ARCHITECTURE PLANNING URBAN DESIGN

RE: 178 Twin Oaks Drive | LOT 1

I reviewed the drawings, and evaluated the site context. My comments and recommendations are as follows:

5. Porch Details

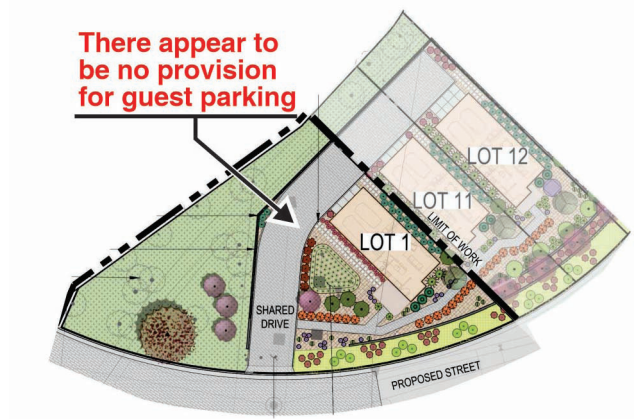
The porch columns and interface with the wall above would not be consistent with Residential Design Guideline 3.10.1.

3.10.1 Porches and Entries

- *Select columns that are traditional to the architectural style of the house. Take care in selecting columns with an appropriate width to height ratio for the style. Except for a very few styles, the columns should have appropriate caps and bases with proportions typical of the style.*
- *Provide a well proportioned beam between the column caps and the roof. Size and detail the beam so that it looks like a convincing structural member. It should be visible both from inside and outside of the porch. ...*

5. Add porch beam and refine columns to be consistent with Residential Design Guideline 3.10.1.
6. Ask applicant what provisions are being made for guest parking.

5. Entry

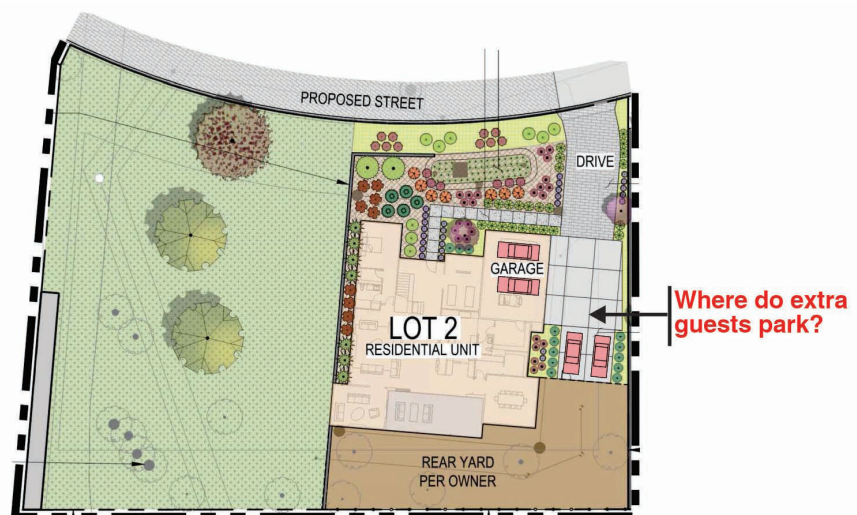
The rectangular entry form would not be consistent with the architectural style and Residential Design Guidelines 3.6.2 and 3.6.3.

3.6.2 Design home entries with sensitivity to the architectural style

3.6.3 Design entries with sensitivity to the surrounding neighborhood

4. Provide trim around all windows and doors - see Los Gatos example below.
5. Eliminate the proposed siding or carry it more consistently around all facades.
6. While the proposed entry type is not normally associated with the proposed architectural style, its recession on the front facade would not be jarring and I would not recommend changing it.
7. Ask applicant what provisions are being made for guest parking beyond the two on site spaces shown.
(e.g., Thanksgiving or other holidays and events)

1. Roof Slopes

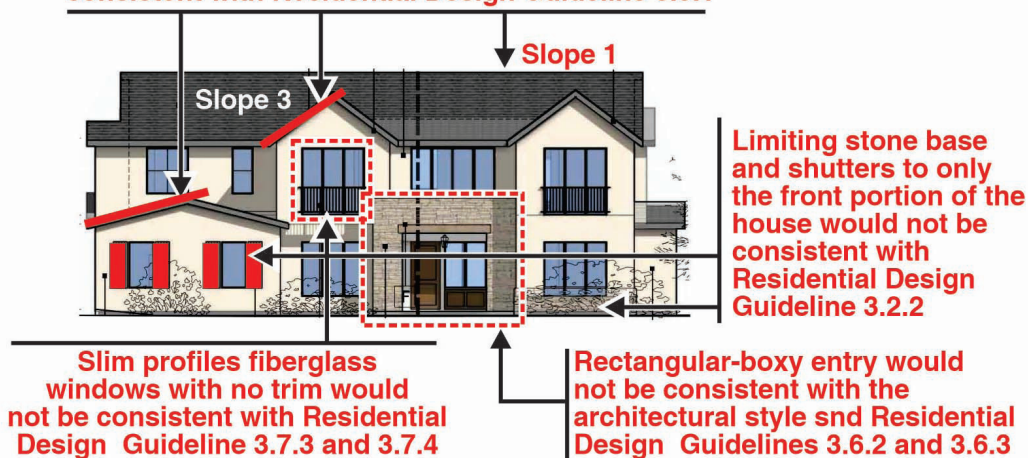
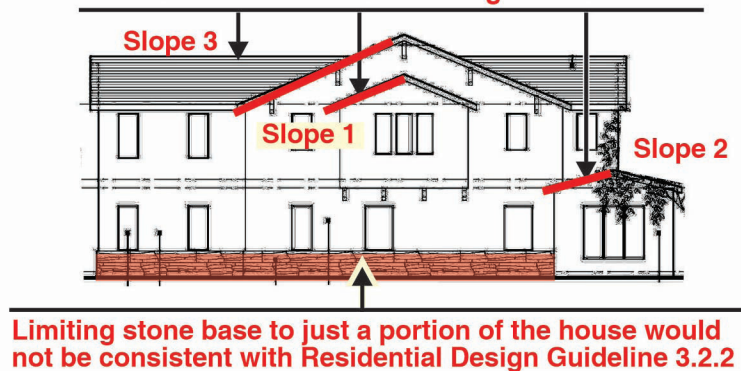
There are three different roof slopes which would not be consistent with Residential Design Guideline 3.5.1.

Three different roof slopes would not be consistent with Residential Design Guideline 3.5.1

Three different roof slopes would not be consistent with Residential Design Guideline 3.5.1

1. Reduce the variation in roof slopes from three to two.
2. Extend the stone base continuously around all four facades or eliminate the base.
3. Select a window with materials and sash width similar to traditional residential windows seen throughout Los Gatos - one example is shown below.
4. Provide trim around all windows and doors - see Los Gatos example below.

1. Roof Slopes

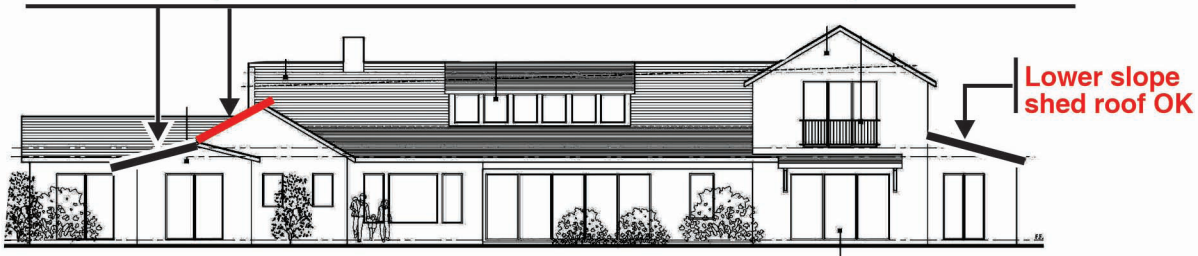
Varied roof slopes would not be consistent with Residential Design Guideline 3.5.1

There are three different roof slopes which would not be consistent with Residential Design Guideline 3.5.1.

Limiting shutters to only the front portion of the house would not be consistent with Residential Design Guideline 3.2.2

Slim profiles fiberglass windows with no trim would not be consistent with Residential Design Guideline 3.7.3 and 3.7.4

1. Reduce the variation in roof slopes from three to two.
2. Select a window with materials and sash width similar to traditional residential windows seen throughout Los Gatos - one example is shown below.
3. Provide trim around all windows and doors - see Los Gatos example below.

2. Facade Integrity

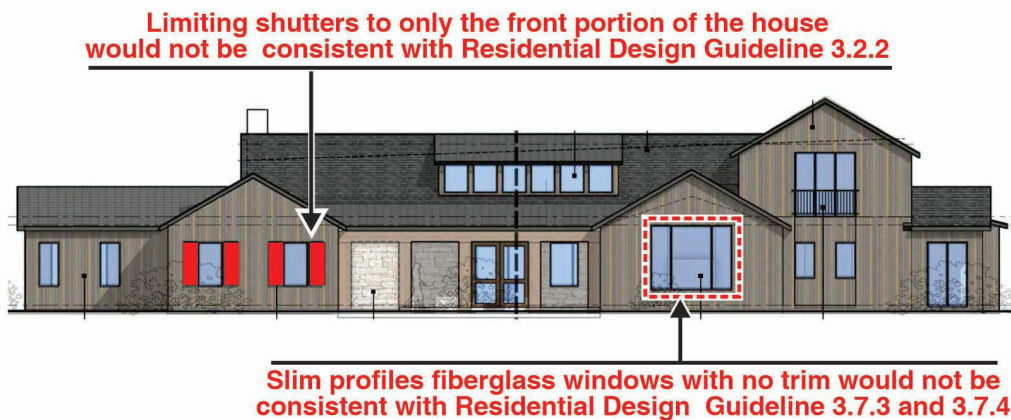
Limiting the location of the stone base and shutters would not be consistent with Residential Design Guideline 3.2.2.

5. Guest Parking

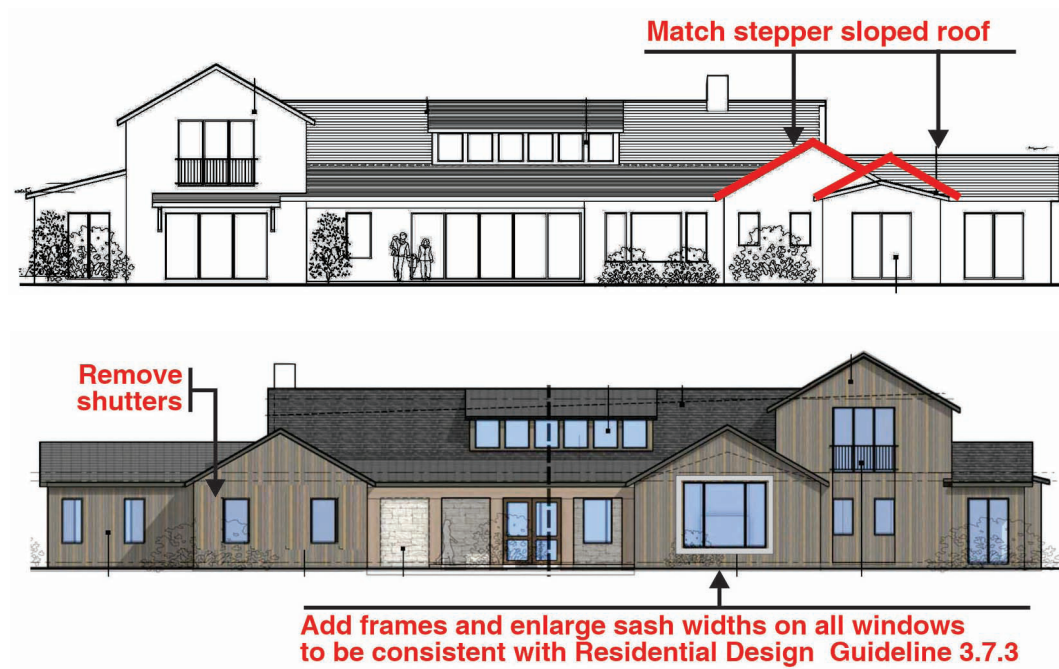
There appears to be limited off street parking for more than two cars and no on street parking is shown.

Parallel parking on plans may be difficult to access and egress

2. Window Trim

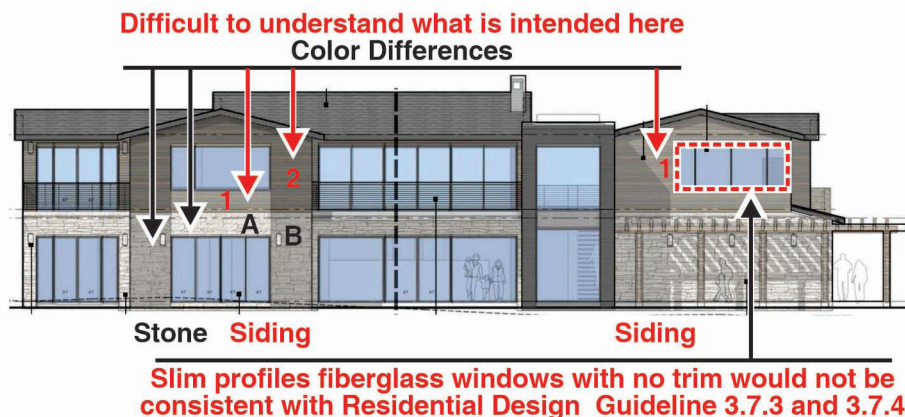
Windows without trim would not be consistent with Residential Design Guideline 3.7.4.

1. Select a window with materials and sash width similar to traditional residential windows seen throughout Los Gatos - one example is shown below.
2. Provide trim around all windows and doors - see Los Gatos example below.

5. Guest Parking

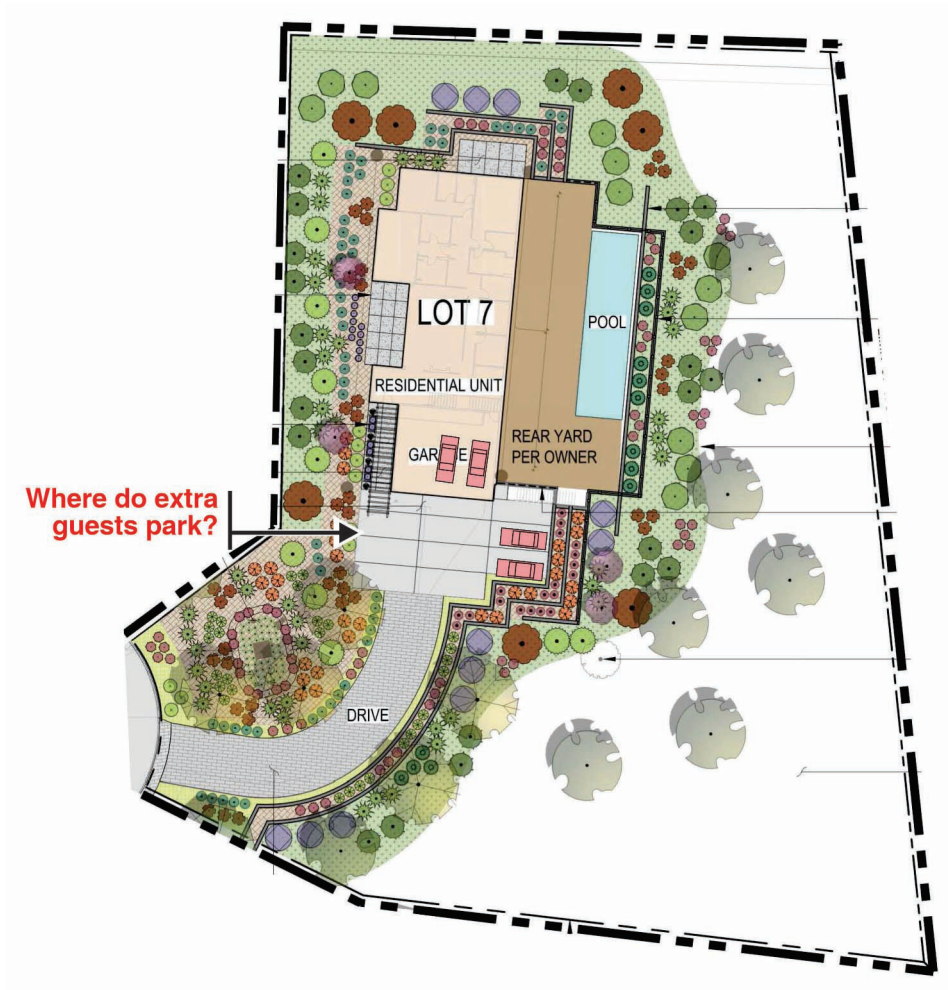
There appears to be limited off street parking for more than two cars and no on street parking is shown.

5. Ask applicant what provisions are being made for guest parking beyond the two on site spaces shown. (e.g., Thanksgiving or other holidays and events)

3. Proposed Facade Materials And Colors

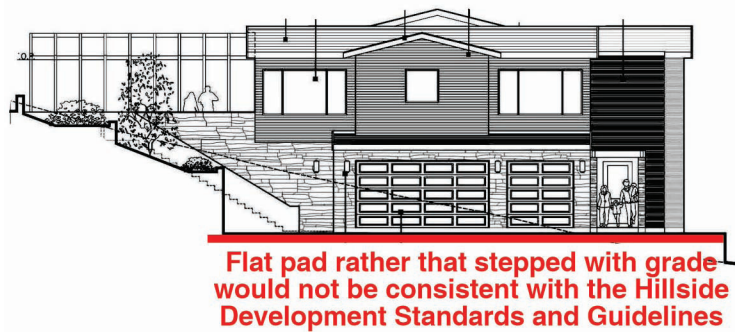
The drawings are difficult to understand.

3. Clarify the indented materials and colors
4. Discuss the grading inconsistency with the town's Hillside Development Standards=S and Guidelines.

5. Guest Parking

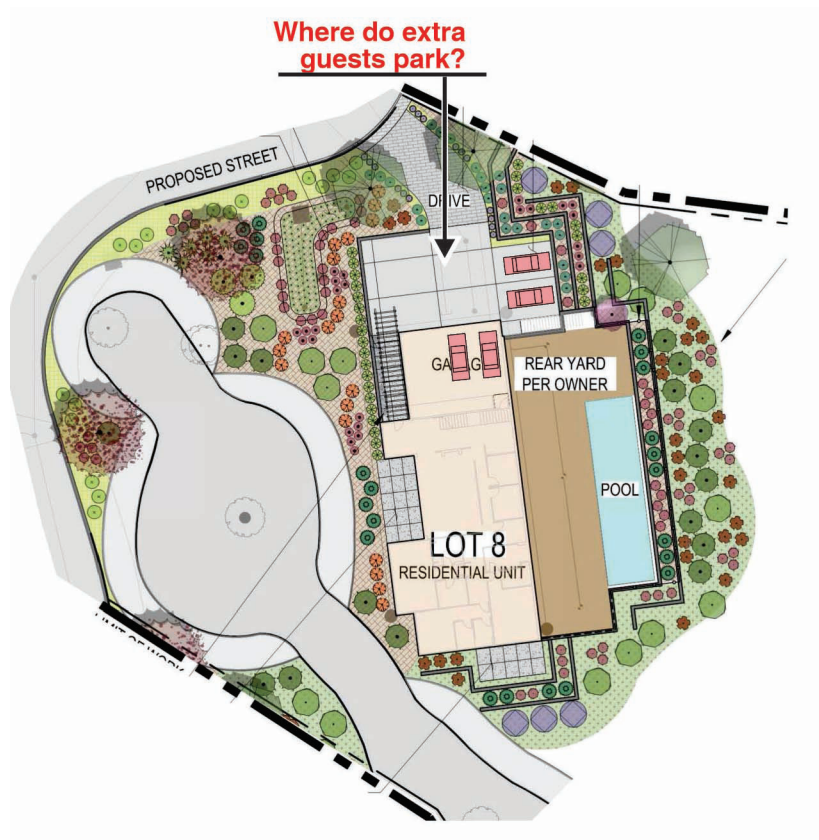
There appears to be limited off street parking for more than two cars and no on street parking is shown.

5. Ask applicant what provisions are being made for guest parking beyond the two on site spaces shown. (e.g., Thanksgiving or other holidays and events)

3. Proposed Facade Materials And Colors

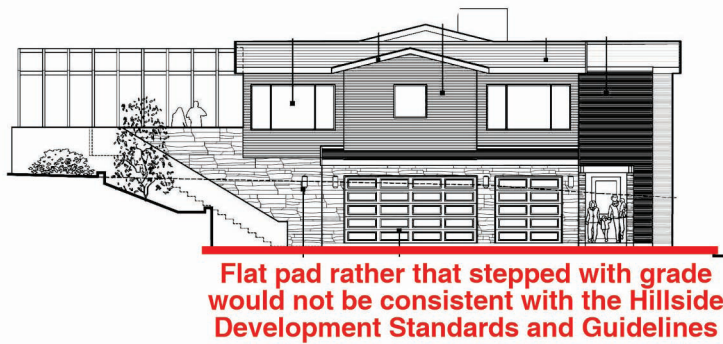
The drawings are difficult to understand.

3. Clarify the indented materials and colors
4. Discuss the grading inconsistency with the town's Hillside Development Standards=S and Guidelines.

5. Guest Parking

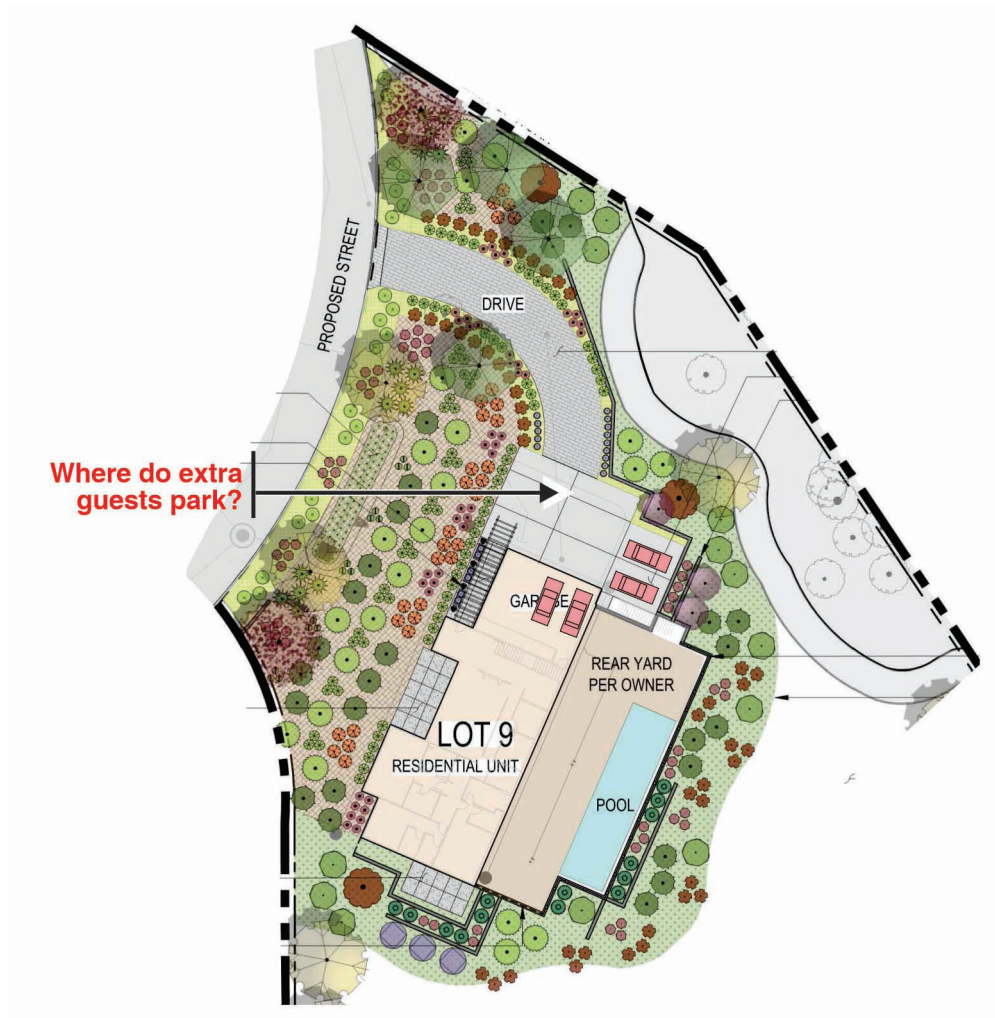
There appears to be limited off street parking for more than two cars and no on street parking is shown.

2. Window Trim

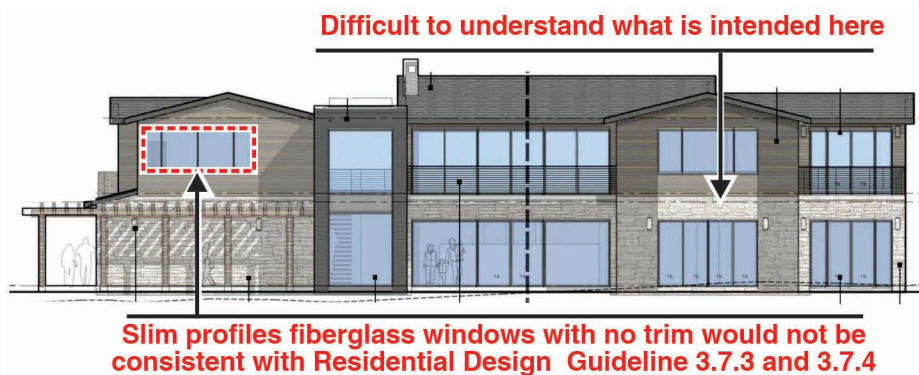
Windows without trim would not be consistent with Residential Design Guideline 3.7.4.

1. Select a window with materials and sash width similar to traditional residential windows seen throughout Los Gatos - one example is shown below.
2. Provide trim around all windows and doors - see Los Gatos example below.

5. Porch Details

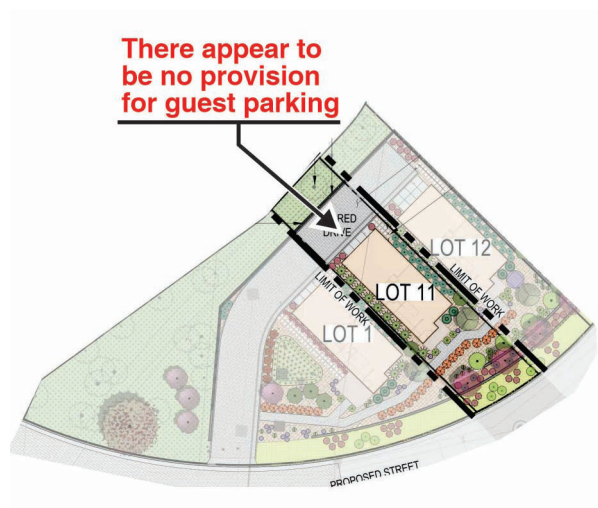
The porch columns and interface with the wall above would not be consistent with Residential Design Guideline 3.10.1.

3.10.1 Porches and Entries

- *Select columns that are traditional to the architectural style of the house. Take care in selecting columns with an appropriate width to height ratio for the style. Except for a very few styles, the columns should have appropriate caps and bases with proportions typical of the style.*
- *Provide a well proportioned beam between the column caps and the roof. Size and detail the beam so that it looks like a convincing structural member. It should be visible both from inside and outside of the porch. ...*

4. Add porch beam and refine columns to be consistent with Residential Design Guideline 3.10.1.
5. Ask applicant what provisions are being made for guest parking.

5. Porch Details

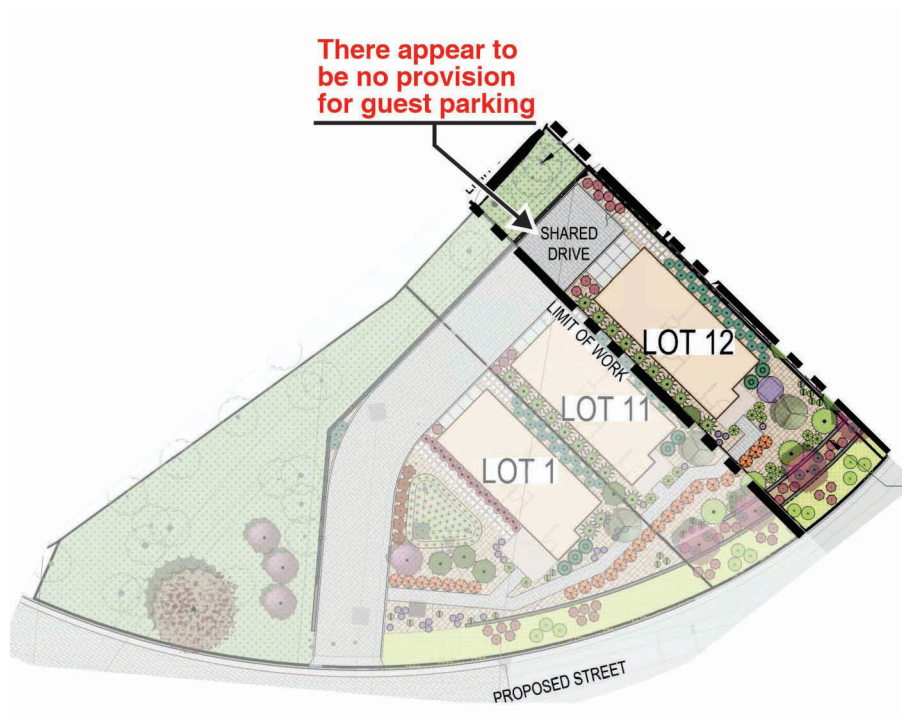
The porch columns and interface with the wall above would not be consistent with Residential Design Guideline 3.10.1.

3.10.1 Porches and Entries

- *Select columns that are traditional to the architectural style of the house. Take care in selecting columns with an appropriate width to height ratio for the style. Except for a very few styles, the columns should have appropriate caps and bases with proportions typical of the style.*
- *Provide a well proportioned beam between the column caps and the roof. Size and detail the beam so that it looks like a convincing structural member. It should be visible both from inside and outside of the porch. ...*

4. Add porch beam and refine columns to be consistent with Residential Design Guideline 3.10.1.
5. Ask applicant what provisions are being made for guest parking.
